Staff Summary Report

SUBJECT: Hold a public meeting for a Development Plan Review for HOTEL @ TEMPE MARKETPLACE located at 65 South McClintock Drive.

DPR07022 – Development Plan Review including site plan, building elevations and landscape plan.

HOTEL @ TEMPE MARKETPLACE

SITE PLAN
NORTH

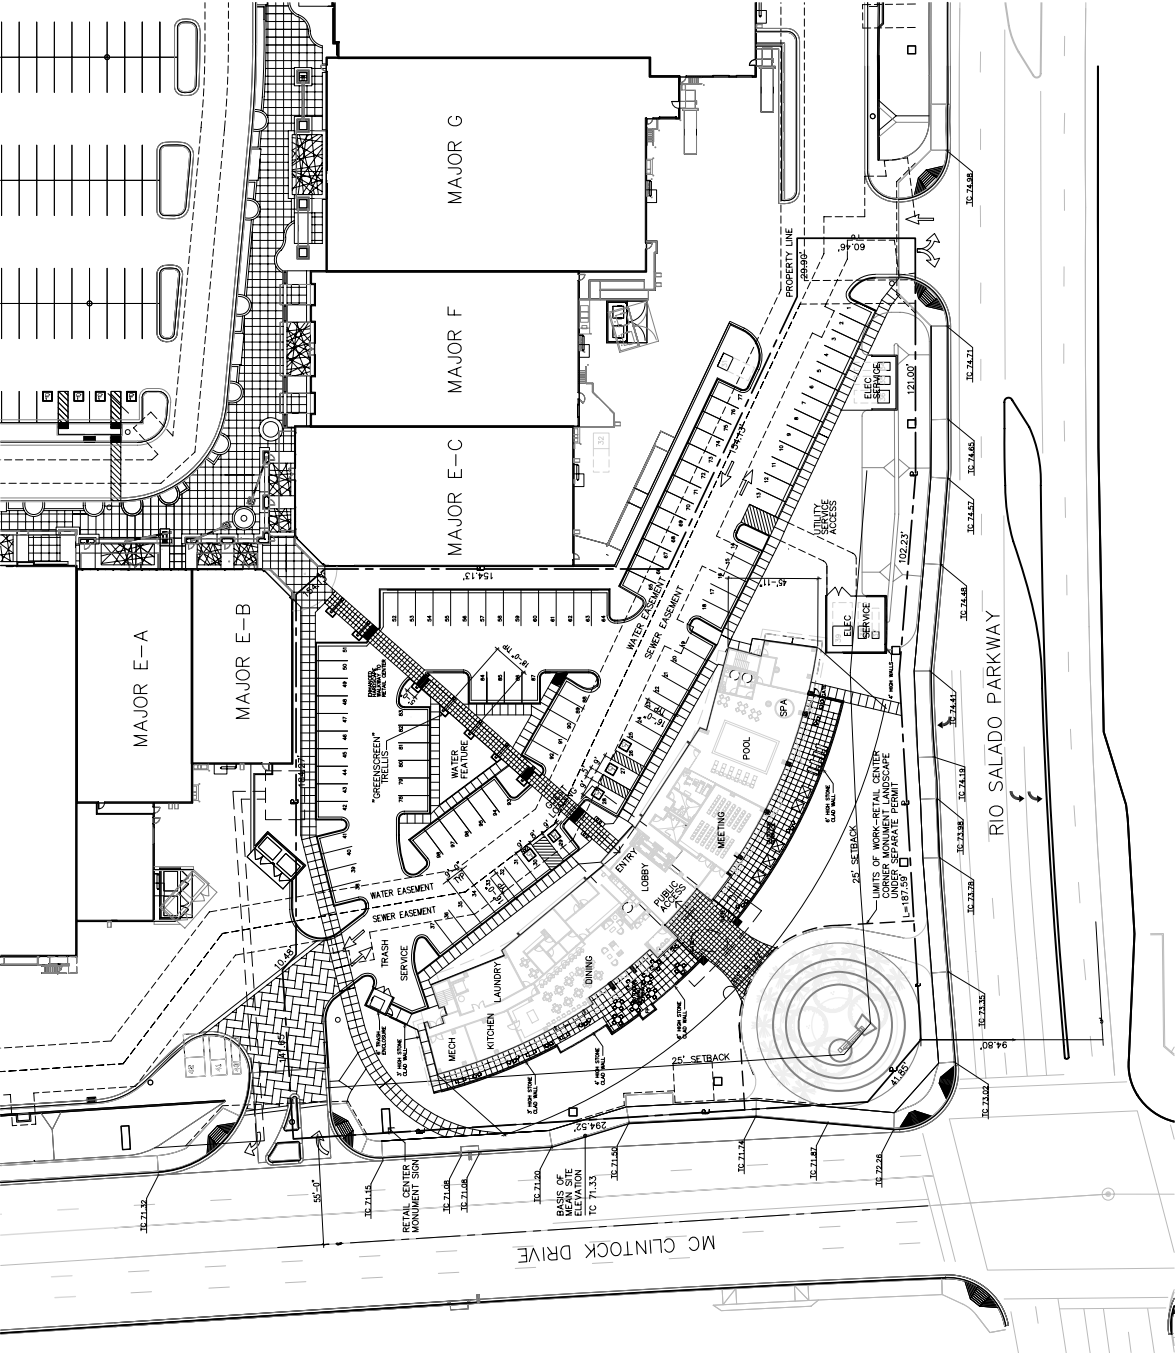
5. Provide 8'-0" wide public sidewalk along arterial roadways, or as required by Traffic Engineering Design Criteria and Standard Details.

6. Provide service yard and mechanical (cooling tower/generator) yard walls that are at least 8'-0" tall as measured from adjacent grade and are at least the height of the equipment being enclosed, whichever is greater. Verify height of equipment and mounting base to ensure that wall height is adequate to fully screen the equipment. Locate electrical service entrance sections inside the service yard, as indicated.

7. Relocate the electrical service entrance section (S.E.S.) enclosure to align with building and/or screen wall to the east. Match wall design with adjacent screen wall materials.

9. Provide upgraded paving at each driveway apron consisting of unit paving. Extend unit paving in the driveway from the back of the accessible public sidewalk bypass to 20'-0" on site and from curb to curb at the drive edges.

10. Distribute bike parking areas nearest to lobby location(s). Provide parking loop/rack per standard detail T-578. Provide 2'-0" by 6'-0" individual bicycle parking spaces. One loop may be used to separate two bike parking spaces. Provide clearance between bike spaces and adjacent walkway to allow bike maneuvering in and out of space without interfering with pedestrians, landscape materials or vehicles nearby.

22. Avoid conflict with proposed trees and existing monument sign on McClintock Drive.
 23. Provide trees within landscape islands at the end of the eastern most parking row and adjacent to refuse enclosure.
